Construction Division
Additions & Alteration Charges Approval Form

GULMOHAR RESIDENCY

Details of Additions & Alterations

Flat No	405	Block no.	' C '
Flat Area	1660 sft	Type	Deluxe / Luxury
Buyer Name	Mr. R Prasad Rao		
Phone No.		Email

Description	Direction	Owners & Developers :	23.09.2020	Promoted by
		Modi Real Estate, Mallapur L.R.	Prepared By :	Modi Properties Pvt Ltd
		Project Name & Phase :	Approved By :	
		Gulmaliat Residency	Scale :	Phone : +91-40-66335551
ELECTRICAL PLAN - 1660 Sft - B1 TYPE

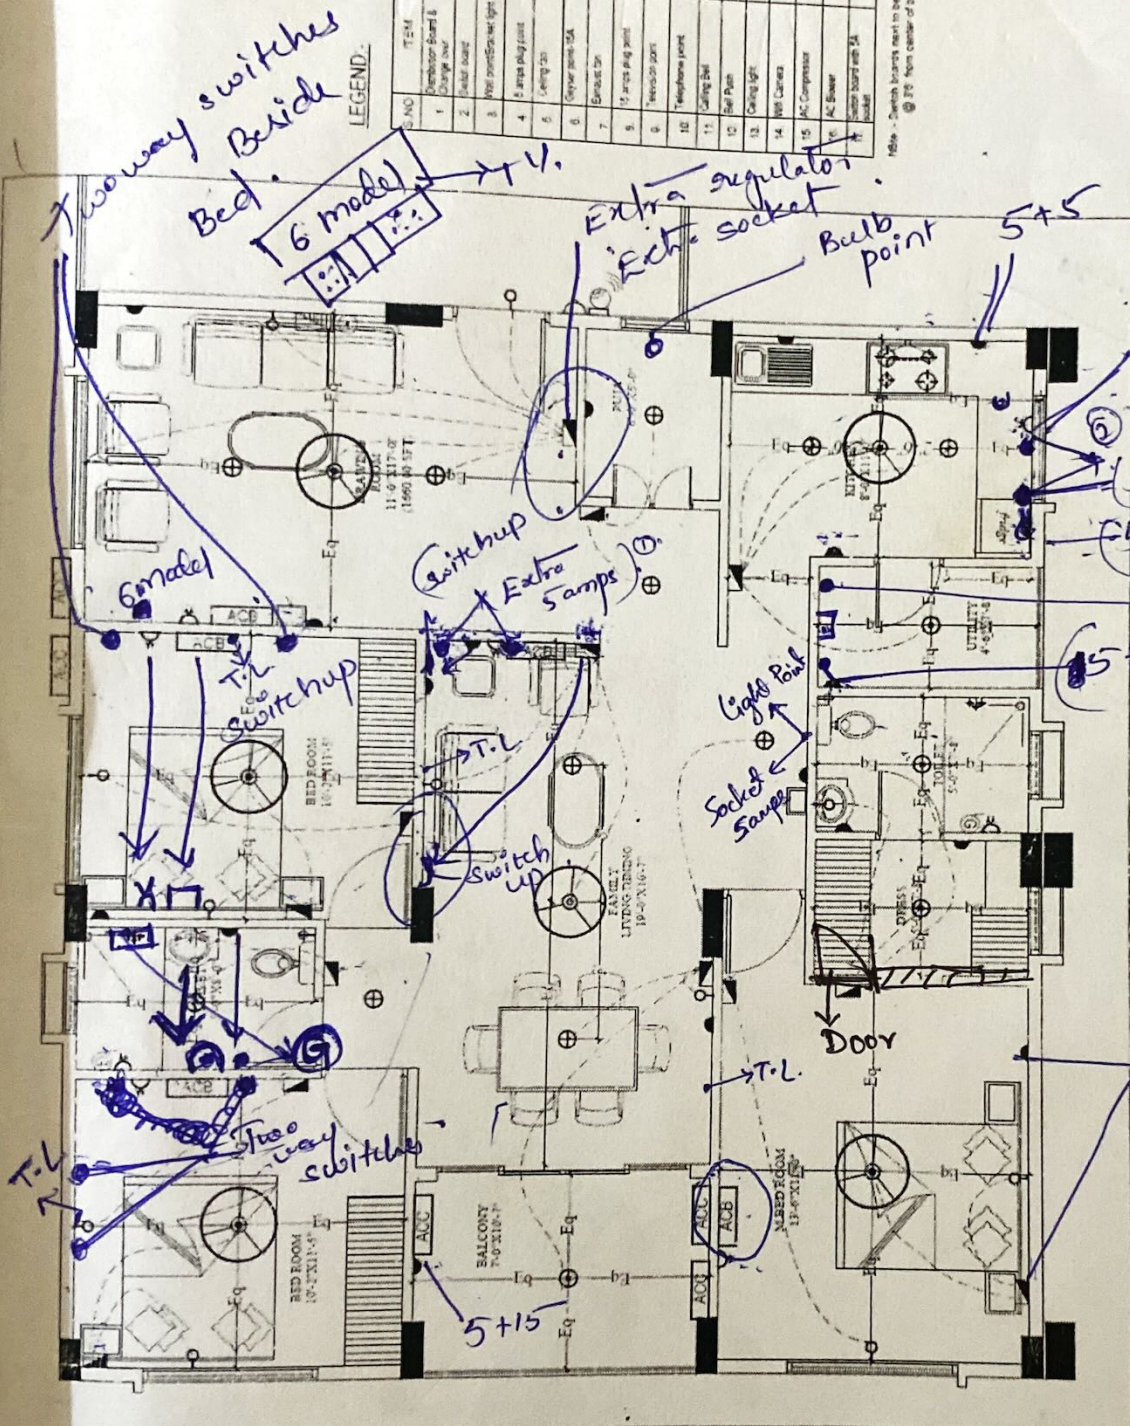
Changes in electrical points: (mark on plan)

- ① For B-Model we required socket points instead of switches.
- ② In all the bedrooms 2-way switches required.

Exhaust fans in all toilets.

① 6 model (1(15amps) x 2(5amps)).

Description		Direction	Owners & Developers	Date	Prepared By	Approved By	Promoted by
WORKING PLAN-1660 Sft-B1 TYPE		N	Modi Reality Mallapur p.p	25.09.2020	Jayapradha	Soham Modi	Modi Properties Pvt Ltd
			Project Name & Phase

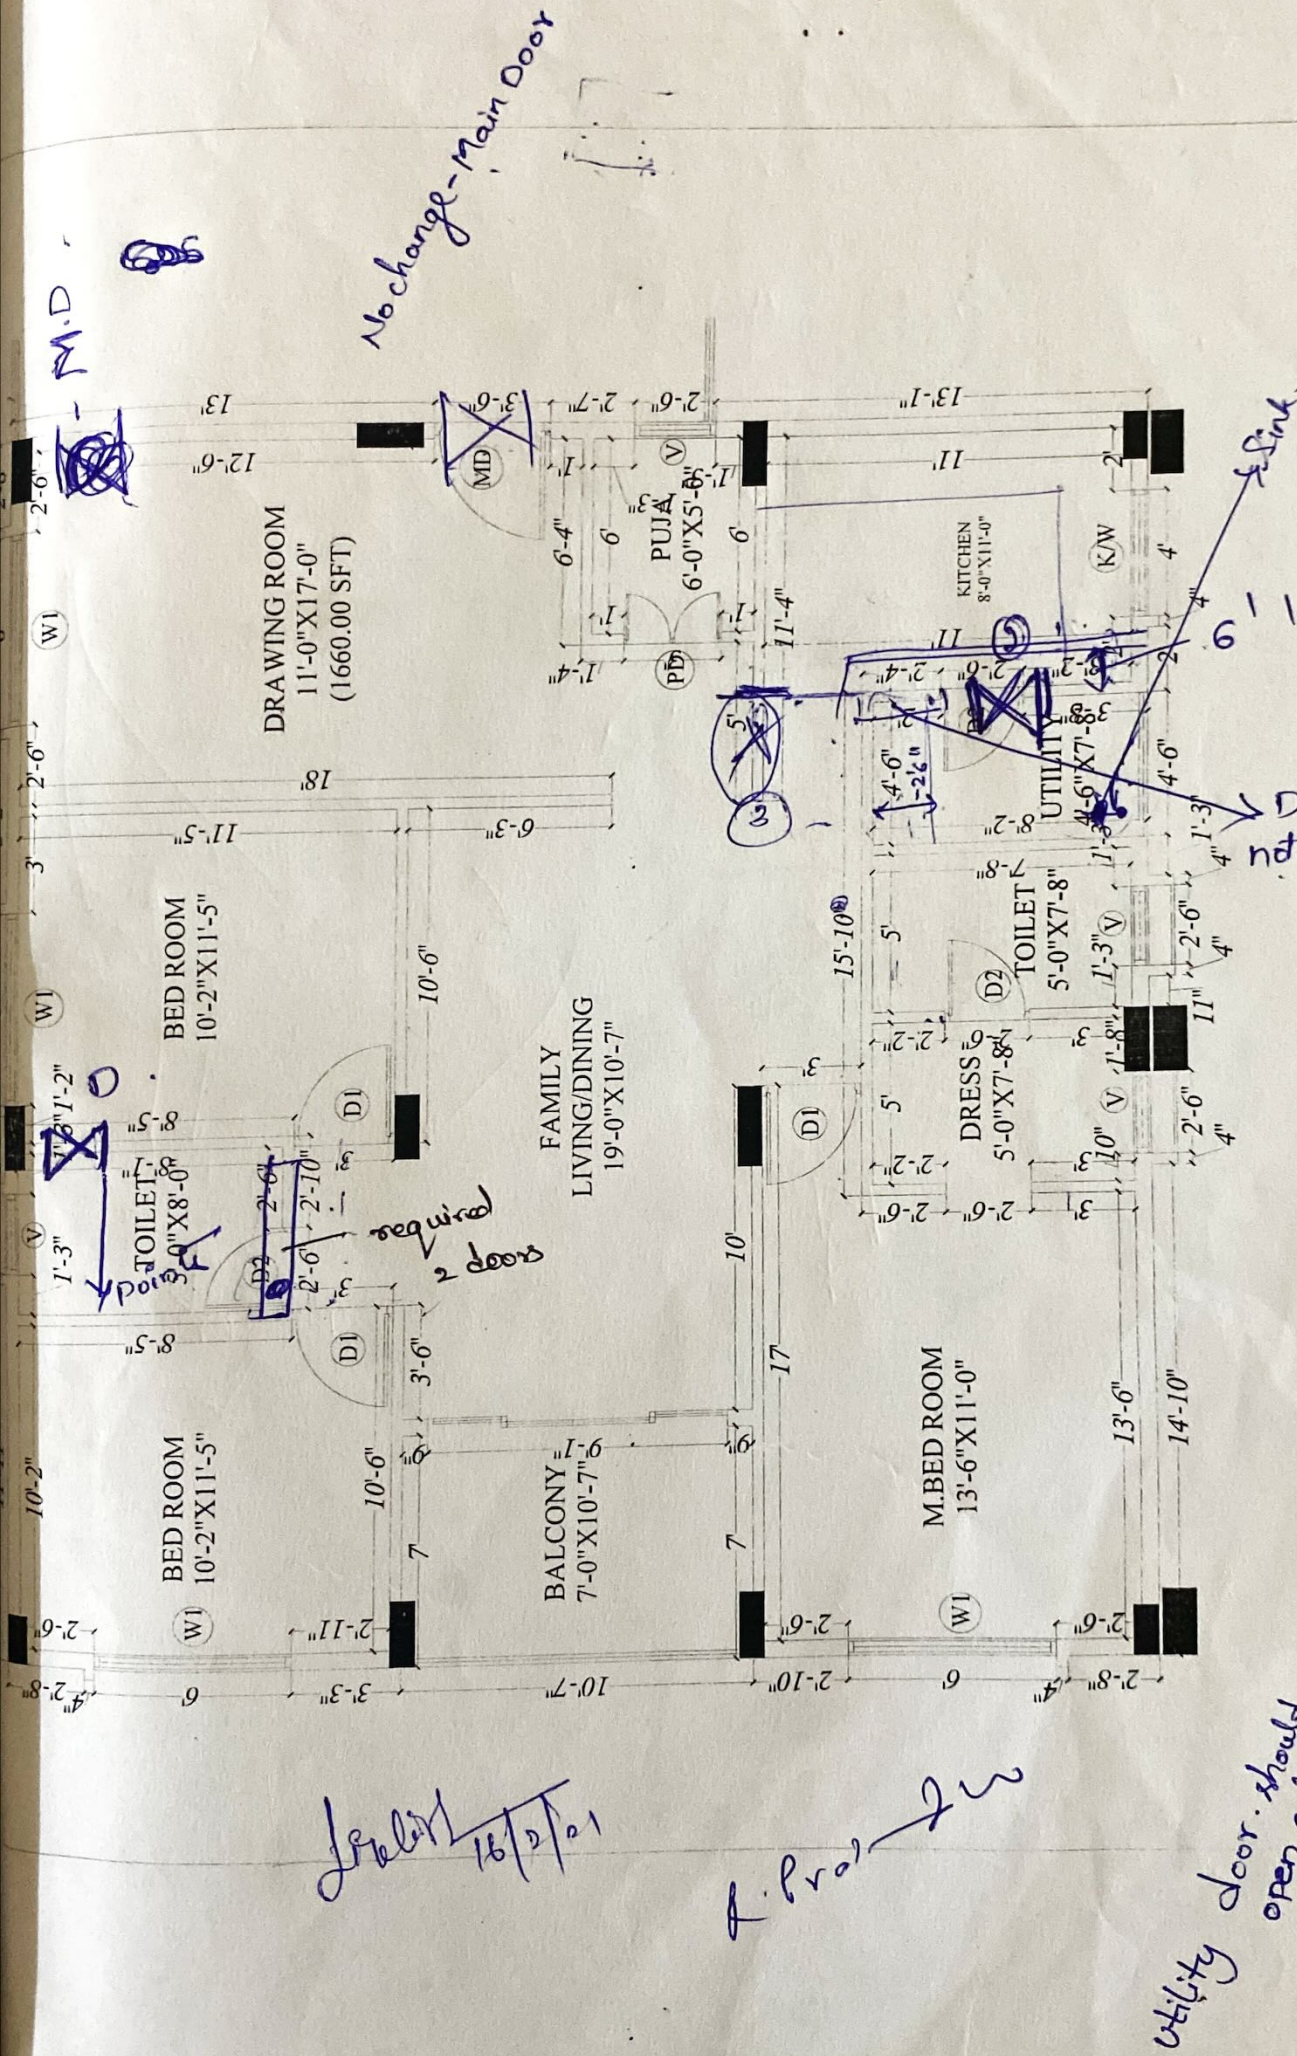
① In pooja room required 4" platform.

② Pooja room to kitchen wall should be reduced as shown in owner drawing. Drawing.

③ Utility room size should be increased to 4'10" x 7'8". (Kitchen size reduced)

④ Utility door re-shifting of door should open out side.

⑧ Dressing door position changing as per owner drawing. Door frame & door to be installed.

⑨ Common toilet doors required ② doors as mentioned in drawing.

⑩ Sink in Common Toilet position has to be changed.

⑪ Kitchen platform has to be increased as per drawing.

Description	Owners & Developers	Date	Promoted by
PLUMBING PLAN-1660 Sft (B1-TYPE)	Modi Reality Mallapur LLP	04.09.20	Modi Properties Pvt Ltd
	Project Name & Phase :	Prepared By :	
	Gulmohar Residency	Approved By :	
		Scale :	
			N T S
			Phone: +91-40-66335551

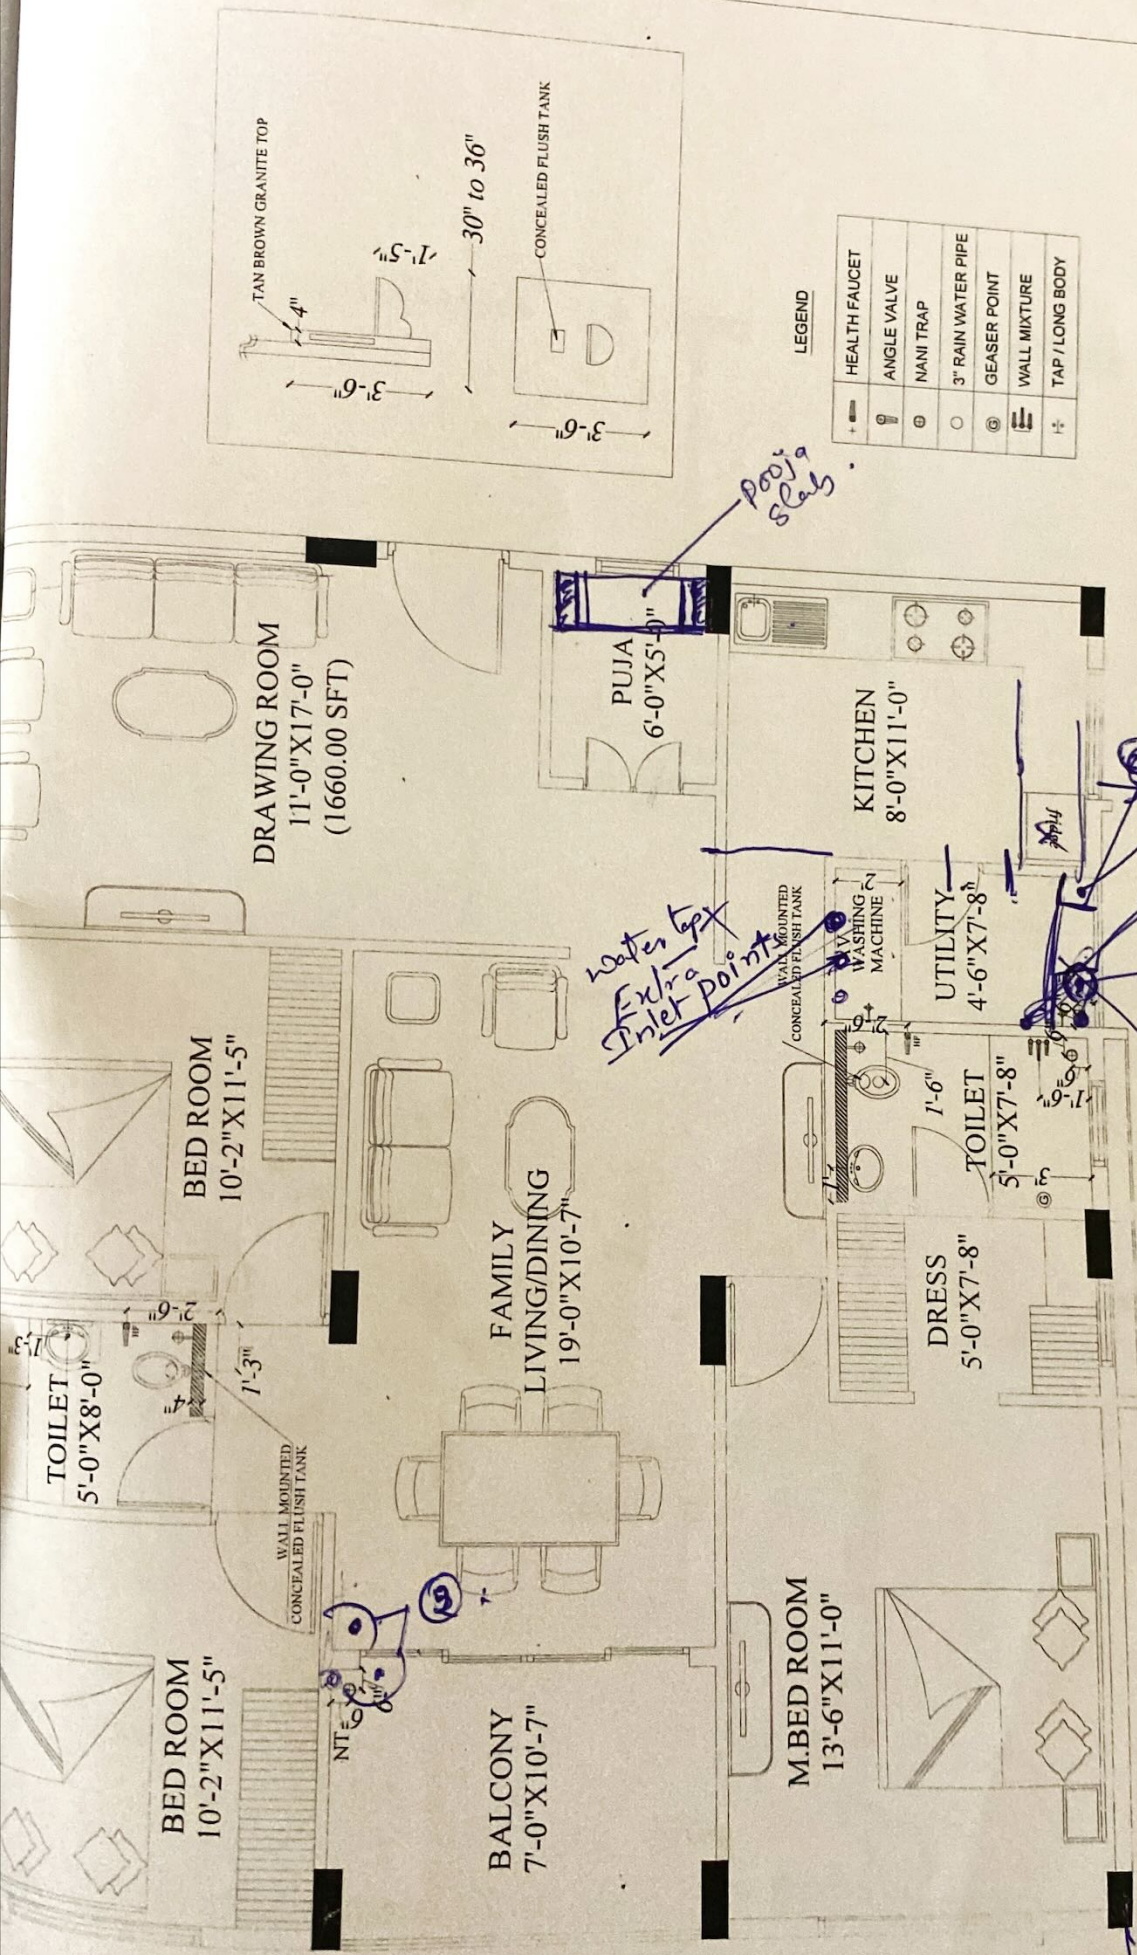
- ① sink point at utility Extra. — ①
- ② Extra wash basin point required @
Balcony (as) French door corner as marked
in plan.
- ③ Common Toilet - Luna
& Master Toilet - Tiles will be laid
by customer.
- ④ Exhaust fans in Bathrooms.

Plumbing Points

(*) Two inlets & outlets in utility of washing & dish washer. -

TYPE B1 - AREA - 1,660 SFT

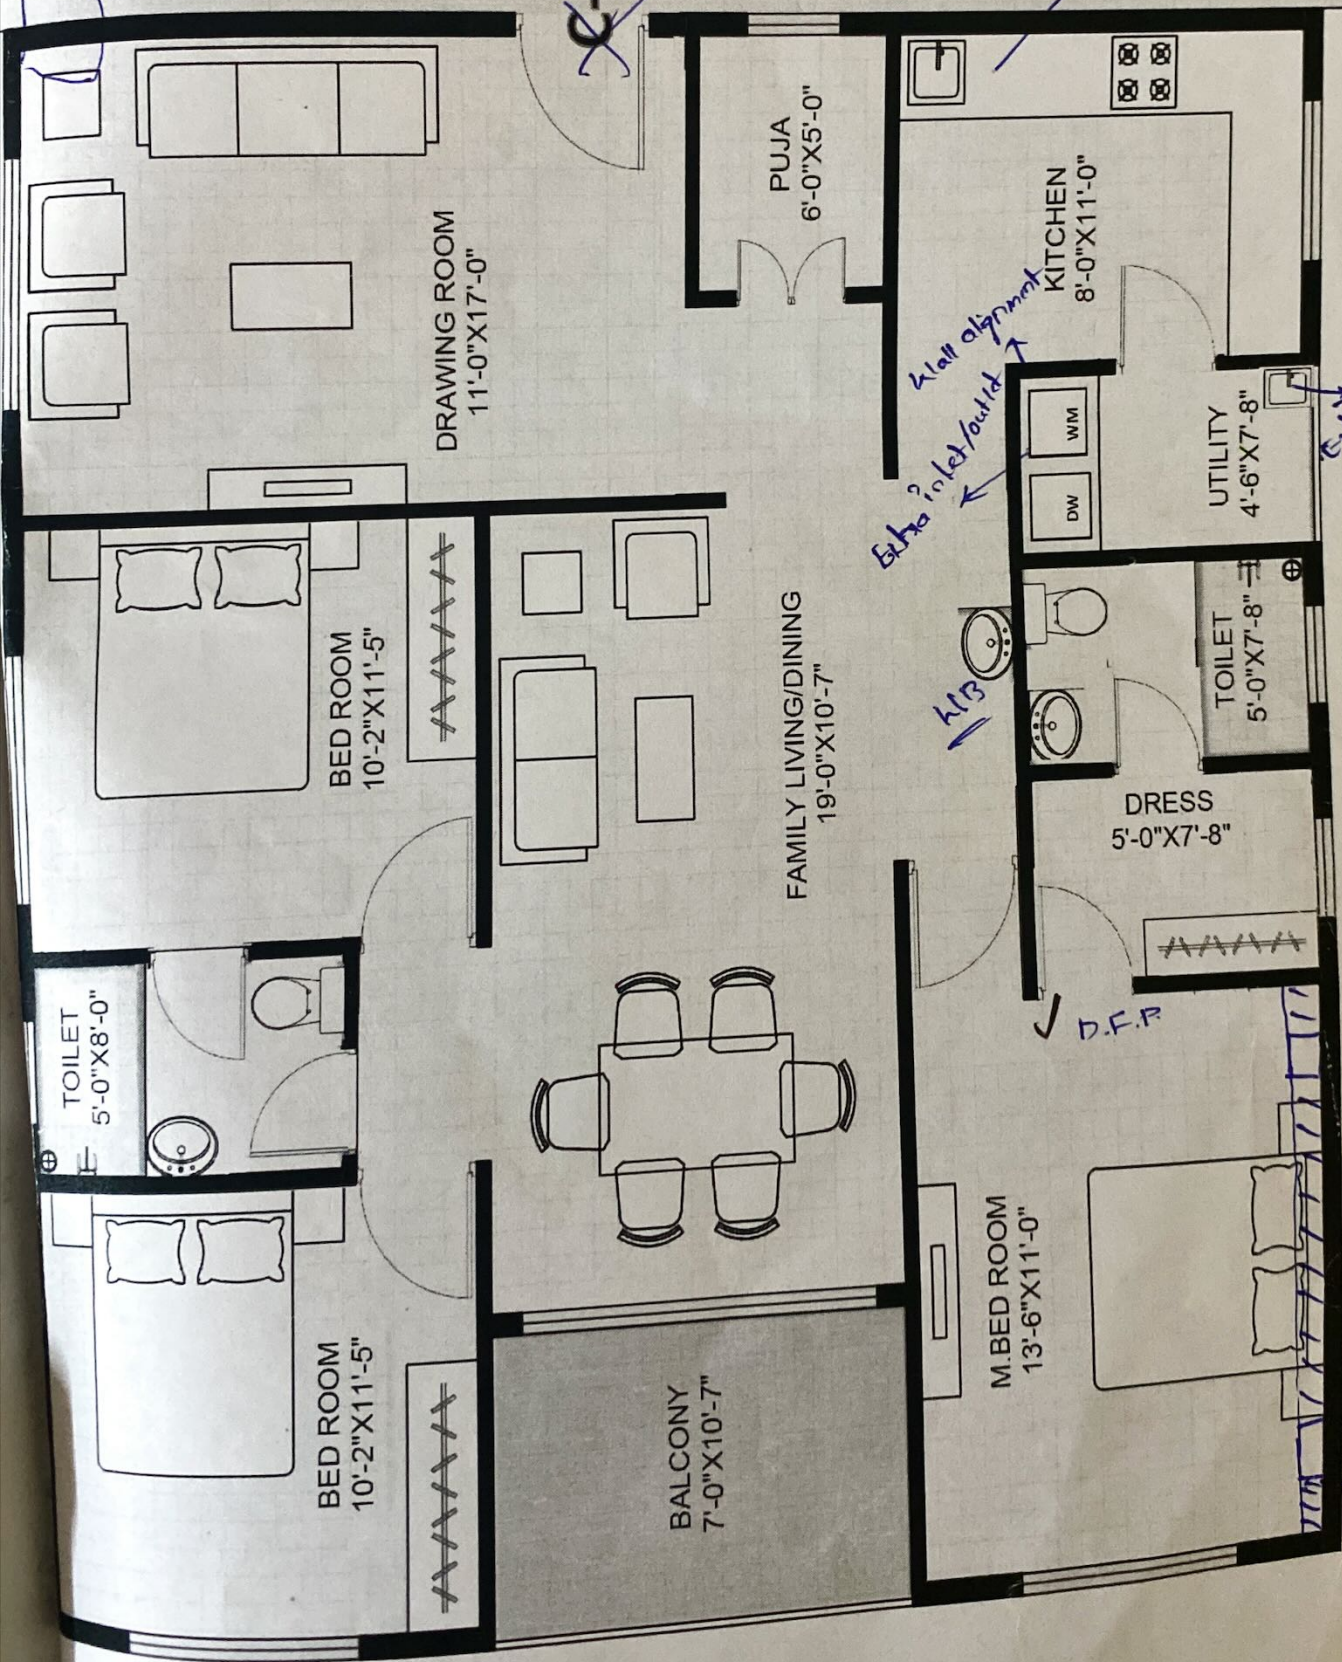
M.D. Shifting.

Modular Kitchen.
